DEPARTMENT OF TRANSPORTATION

Contract #: 04-0120F4Cty: SF/ALA Rte: 80 PM: 13.2/13.9File #: 69.28**WELDING INSPECTION REPORT****Resident Engineer:** Pursell, Gary**Address:** 333 Burma Road**City:** Oakland, CA 94607**Report No:** WIR-013154**Date Inspected:** 24-Mar-2010**Project Name:** SAS Superstructure**OSM Arrival Time:** 700**Prime Contractor:** American Bridge/Fluor Enterprises, a JV**OSM Departure Time:** 1900**Contractor:** Zhenhua Port Machinery Company, Ltd (ZPMC), Changxing Island **Location:** Shanghai, China**CWI Name:** Li Yang**CWI Present:** Yes No**Inspected CWI report:** Yes No N/A**Rod Oven in Use:** Yes No N/A**Electrode to specification:** Yes No N/A**Weld Procedures Followed:** Yes No N/A**Qualified Welders:** Yes No N/A**Verified Joint Fit-up:** Yes No N/A**Approved Drawings:** Yes No N/A**Approved WPS:** Yes No N/A**Delayed / Cancelled:** Yes No N/A**Bridge No:** 34-0006**Component:** OBG Segment**Summary of Items Observed:**

ZPMC SHIP # 17

ZPMC SHIP # 17 (Lift 5E)

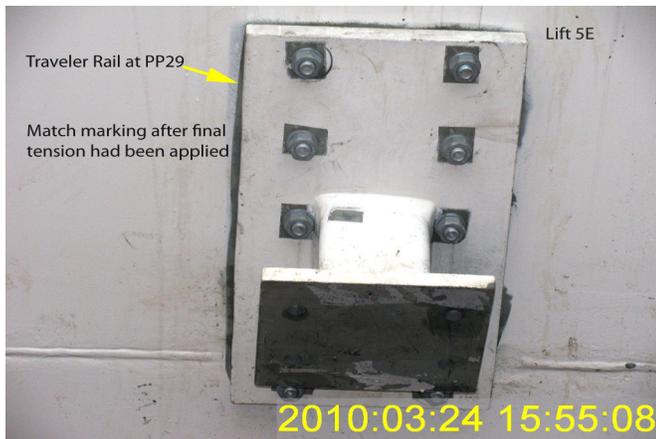
The Caltrans Quality Assurance (QA) Inspector observed that the tightening of the bolts were not performed per the approved procedure.

- Marking bolts after final tension had been applied at Traveler Rail located at PP 29.
- ZPMC workers were performing final bolt tightening of ASTM A325 bolts by turn-of-nut specification of 180° to 210°.
- This issue is located at Lift 5E Traveler Rail at PP 29 to PP 36 (Bike path side)
